DEVELOPMENT APPLICATION ASSESSMENT REPORT

Application Number:	DA2021/2239
----------------------------	-------------

Responsible Officer:	Thomas Burns
Land to be developed (Address):	Lot 170 DP 15376, 255 Whale Beach Road WHALE BEACH NSW 2107
Proposed Development:	Alterations and additions to dwelling house including a swimming pool
Zoning:	C4 Environmental Living
Development Permissible:	Yes
Existing Use Rights:	No
Consent Authority:	Northern Beaches Council
Land and Environment Court Action:	No
Owner:	Sally Ann Constable Peter Charles Constable
Applicant:	Nanna Margrethe Lesiuk

Figure 2: area of swimming pool that encroaches into foreshore area (highlighted in purple)

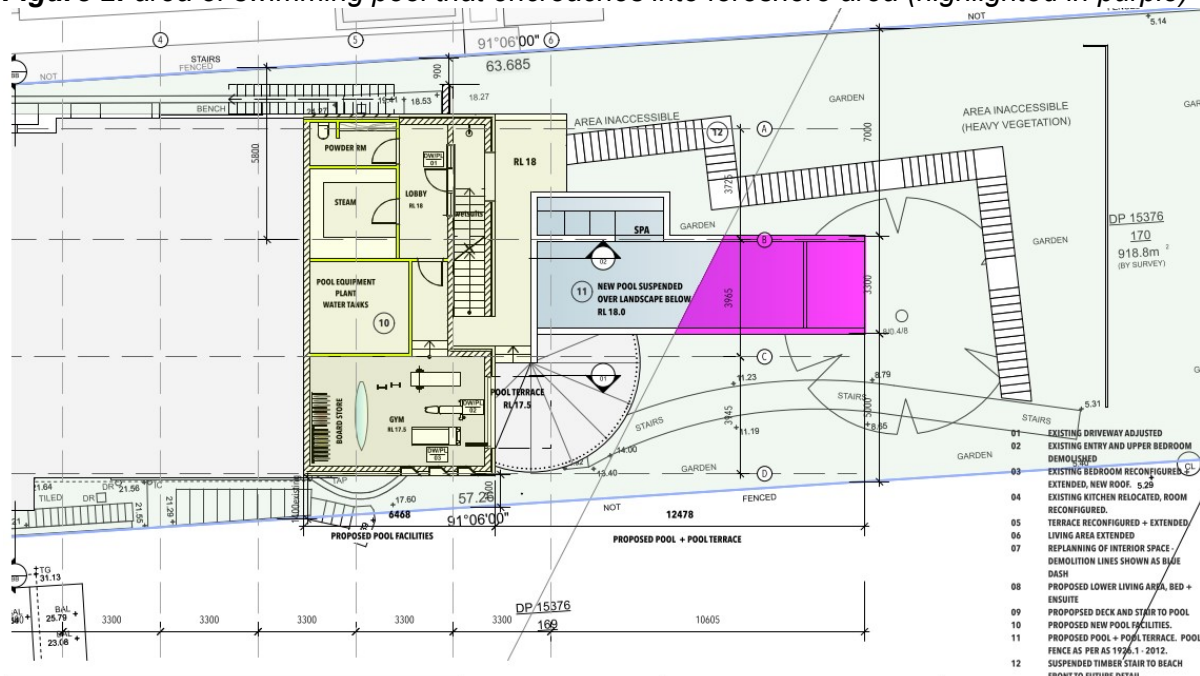
The proposed development includes a new suspended swimming pool that encroaches into the foreshore area. It is noted that swimming pools are permitted within the foreshore area. Figure 2 below depicts the extent of the swimming pool that encroaches into the foreshore area.

Figure 8: areas of building outside of side building envelope on southern elevation

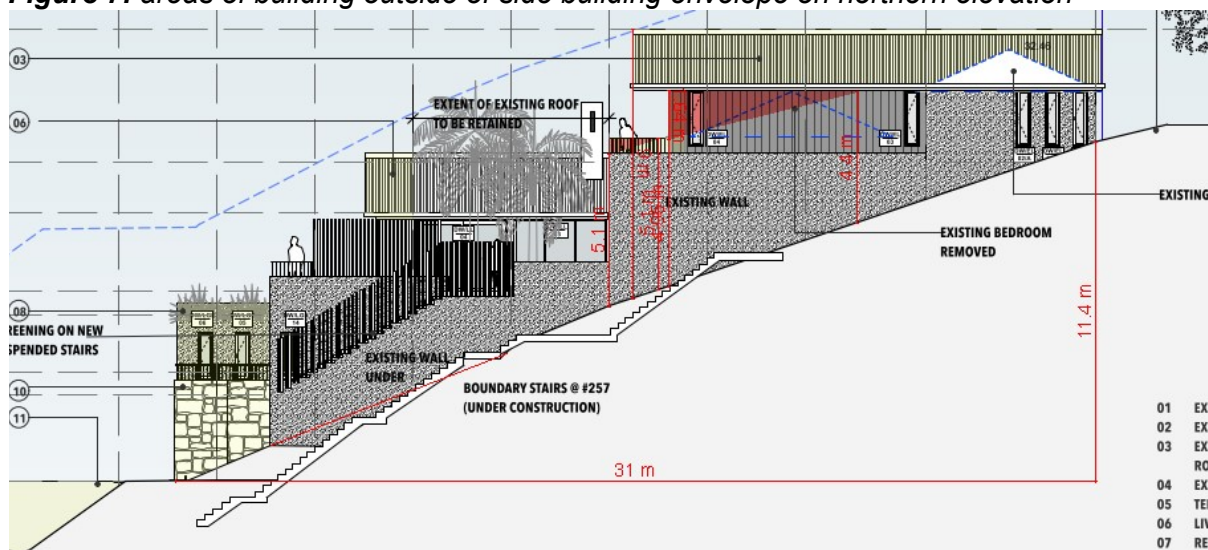
Components of the new additions protrude outside of the prescribed side building envelope on the northern and southern elevations, as depicted in Figures 7 and 8 below.

Notwithstanding, control permits a variation provision which states that the building envelope assessment will be subject to a merit assessment where the building footprint is situated on a slope over 30%. The site topography directly under the building footprint has a 39.94% slope and therefore, the proposal is subject to a merit assessment.
